B2901A-02

# Modification Recommended Service Note

## B2901A Precision Source/Measure Unit, 1ch, 100fA resolution, 210V, 3A DC/10.5A pulse

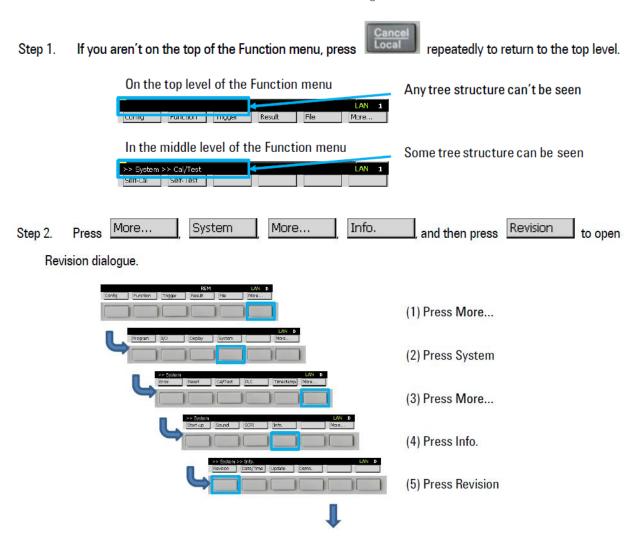
The B2901A with the following firmware revisions may have an internal communication error. This error may occur at the power on or when updating the firmware to the below revisions.

Firmware revision: 3.1.1645.5820 Firmware revision: 3.2.1744.8690 Firmware revision: 3.3.1815.4700

And it can be solved by installing the Firmware revision 3.3.1829.4835 or later.
